**RE: Docket 4783 - Proposed FY 2019 Electric Infrastructure, Safety, Reliability Plan
Responses to Division Data Requests – Set 1**

The Narragansett Electric Company
d/b/a National Grid
RIPUC Docket No. 4783
In Re: Electric Infrastructure, Safety, and Reliability Plan FY2019
Responses to the Division's First Set of Data Requests
Issued on December 26, 2017

Figure 1: Feeder 13F4, Unmet Demand and State of Charge with 3MW/15MWh battery, 2030 peak day load

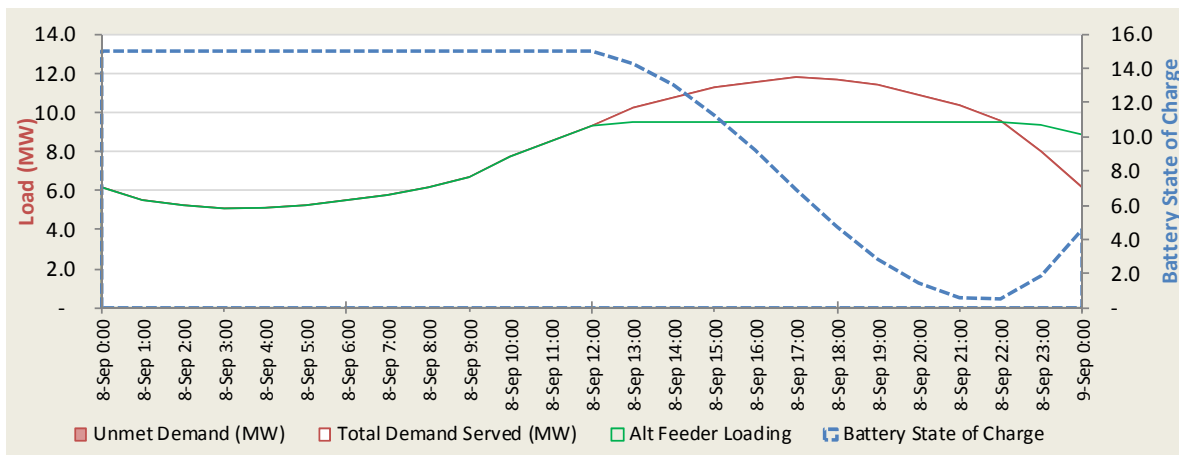
The Company's Providence Area Study references the evaluation of a non-wires alternative (NWA) required in 2030 used to resolve a capacity violation on the Clarkson Street 13F4 and 13F5 feeders. For this evaluation, provide all work papers including a detailed discussion of the violation, calculation of required MW or MWh reduction, cost estimate of the NWA, forecasted feeder loading before the NWA solution is applied, and forecasted feeder loading for a fifteen year period after the NWA solution is installed. Include a detailed comparison of the NWA to the preferred solution.

The analysis identified a solution in the form of two separate battery storage systems, one at Geneva to serve 13F4 and one at Marquetteville to serve 13F5. The performance of these systems is shown in Figures 1 and 2, assuming a 3MW/15MWh system at Geneva, and a 6MW/36MWh system at Marquetteville.

As the figures show, the proposed 6MW/36MWh system for 13F5 does not avoid lost load altogether. Rather, both suggested systems achieve approximately 12 hours of relief during peak hours to allow time for getaway cable repair. The main difference between the graphs arises from the severity of the conditions on feeder 13F5, where load requirements even under proposed switching actions would be significantly higher than load requirements on feeder 13F4. In both cases, achieving this level of relief would require that the batteries be held in full state of charge (SOC) during peak months, and at a relatively high SOC during shoulder periods.
